From: Samuel F. Herzberg
Sent: Wednesday, December 07, 2016 1:23 PM
To: Jonathan Berlin; Stephen Svete
Cc: Sarah Birkeland; Carla Schoof
Subject: FW: Do NOT "develop" Flood Park! Keep it AS IT IS!

Subject: Concerns regarding some aspects of the Preferred Plan for Flood Park

The San Francisco Public Utilities Commission (SFPUC) recently received a Notice of Preparation from San Mateo County (Lead Agency) for the Flood County Park Landscape Plan Draft Environmental Impact Report (DEIR). Thank you for the opportunity to comment on the scope of the DEIR.

Presented December 9 + 16 as Final Plan - Soccer Field
moved and enlarged

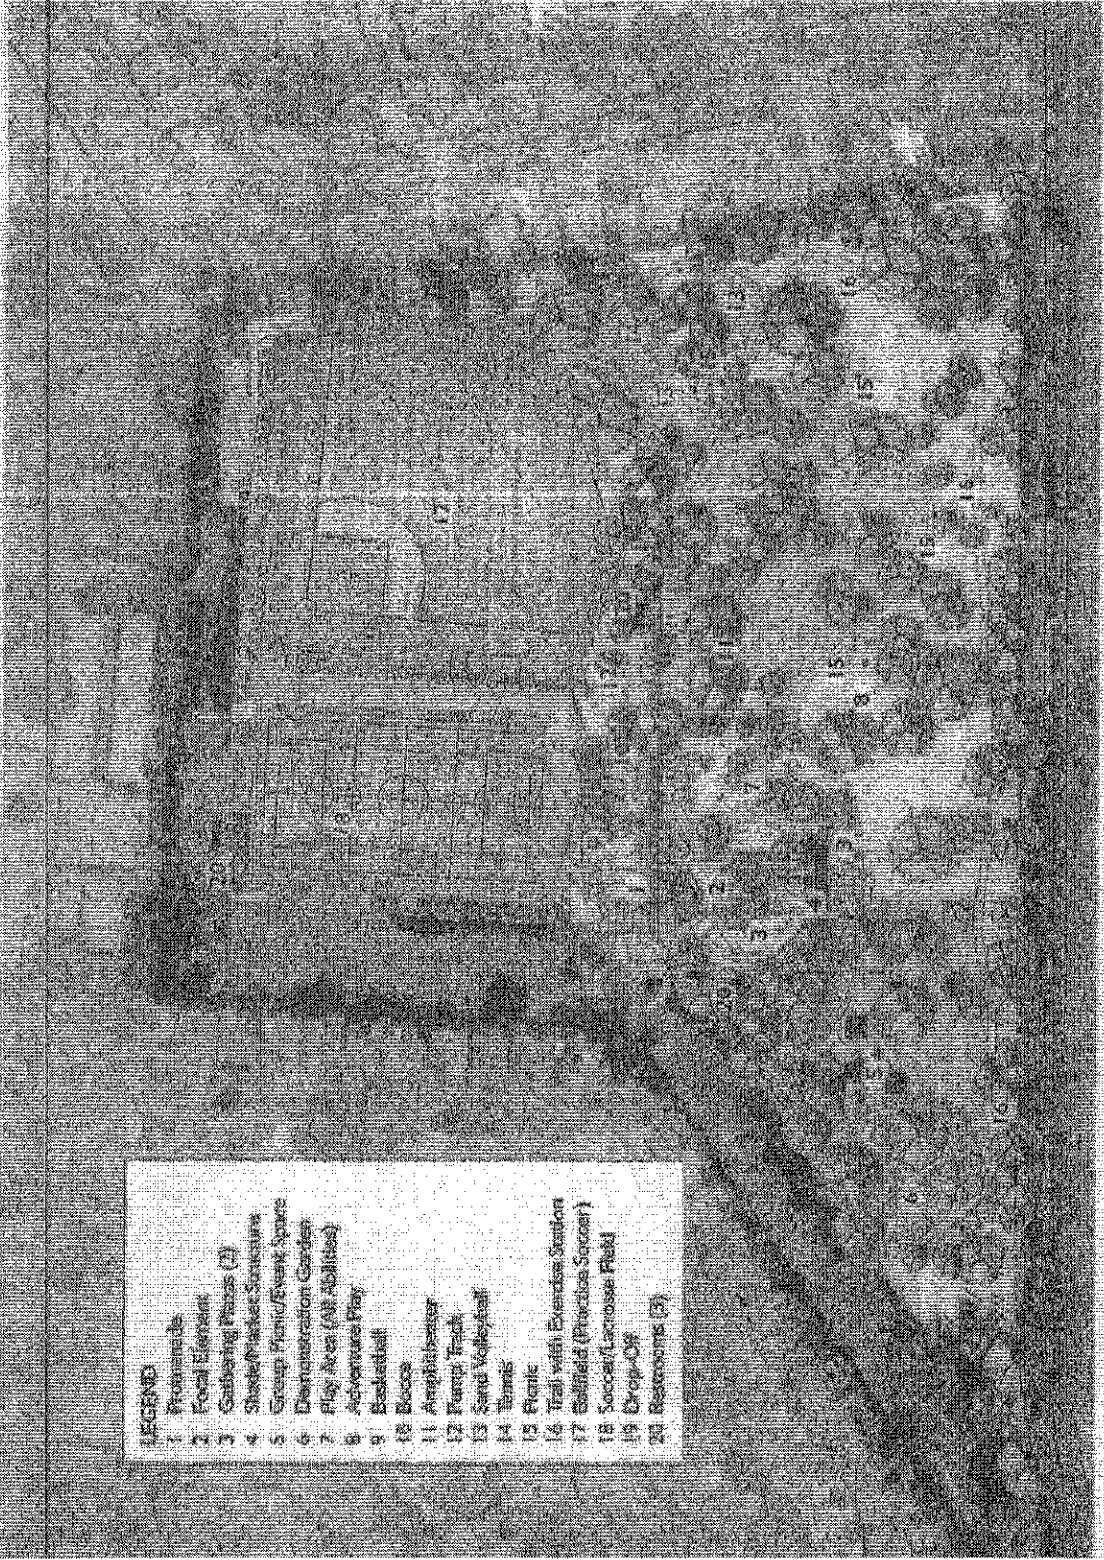
I am attaching some questions to be included in the EIR including a rough layout of another proposed plan reversing the 2 large fields with the ball park bull pen in the center of the park and the outfield close to Del Norte and Iris Ln. There will need to be some room in between the 2 fields for players to gather and for seating, but I am quit sure there should be enough room to do this. If for some reason there does not seem to be enough space, consider dropping the lacrosse portion of the soccer field, as a lacrosse field is 60 yards wide while the smallest full size soccer field is 50 yards wide. That is an additional 30 feet of space. Lacrosse was not even identified as a need by the community when the County started this process, and somehow has become a high priority item.

2. Noise and dust from leaf blowers – the current 'Preferred Plan" shows a walking pathway between neighbor's property lines and the edge of the current proposed field (a total space of only 30 feet). I assume leaf blowers will be keeping these pathways clean. How are you going to control dust being blown into neighbor's yards? How are you going to mitigate the noise from these leaf blowers, especially early in the morning? How are you going to ensure that dust from blowing leaves so close to mine and other neighbor's yards is not going to affect health negatively (i.e. dust allergies)?
